ENERGY STAR®

Pool Pumps

Draft 2, Version 2.0/Version 3.0
Recommended Changes

Chuck Thomas
Technical Leader

184 | Figure 1. Connected Pool Pump System (CPPS)

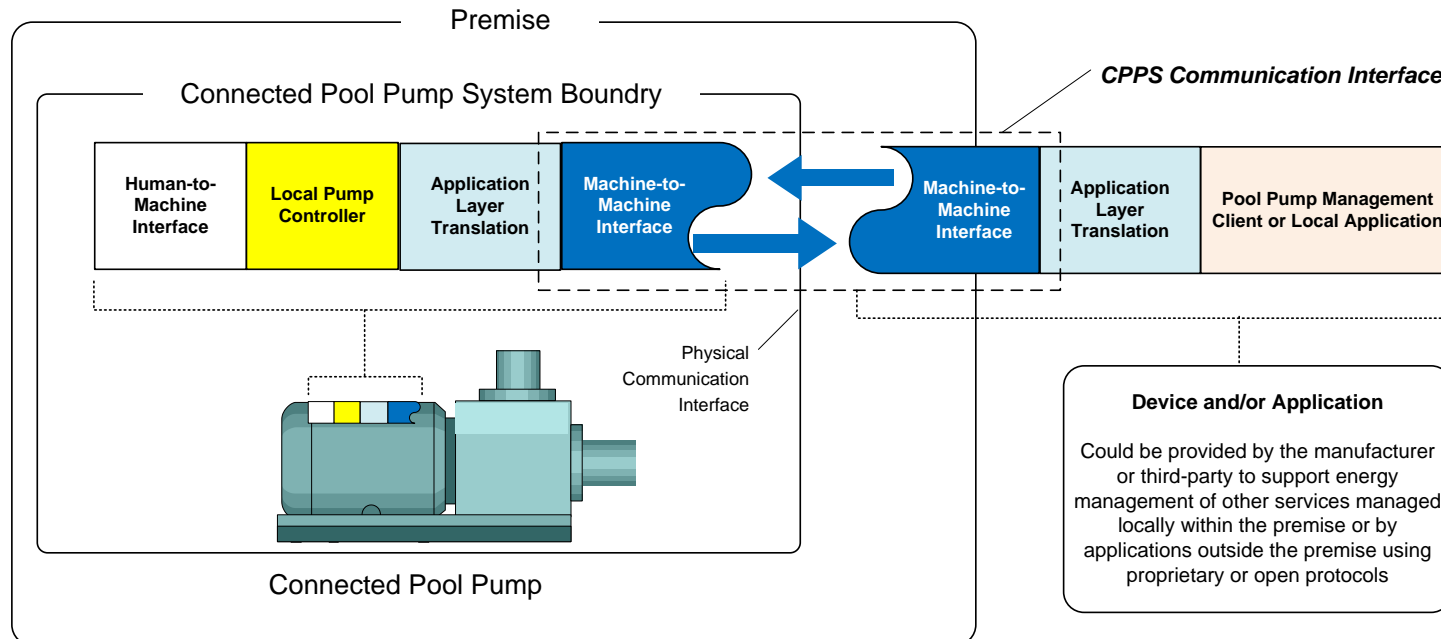
Recommendation is to change Figure 1 to provide a conceptual understanding of the requirements defined herein. The intent is to show that the open communication interface must be incorporated into the pump system located within the premise.

The recommended text along with the diagram in Figure 1 helps to defined the demarcation point between the CPPS and devices and/or applications that the consumer could add to utilize .

177	1.6 Connected Products
178	A) Physical Communication Interface: As shown in Figure 1, the mechanism for bi-directional data
179	transfers between the CPPS and a device and/or application.

180	B) Connected Pool Pump System (CPPS): Refers to the physical boundary between the communication interface of an ENERGY STAR certified pool <i>pump</i> and communication
181	interface of external devices and/or applications provided by the manufacturer or third- parties
182	to enable connected functionality.

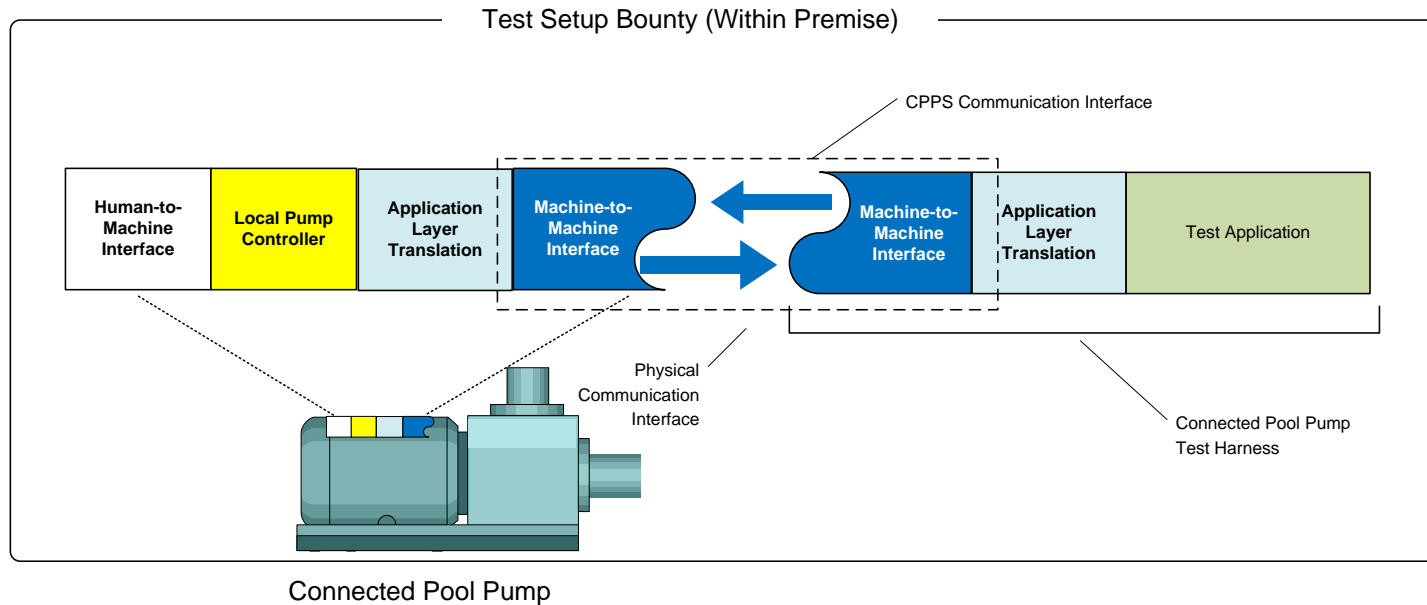
Since the test plan for connected functionality has not been developed, it's recommended that the above be used to define the "Test Harness"

If recommendations included are accepted, any third-party of independent test agency and test the pump and connected functionality locally, at the pump, without having to contact the manufacturer.

The test harness(s) could be standardized and used by OEMs to develop and test their technologies prior to submission, helping to ensure interoperability between technologies tested against the same test harness.
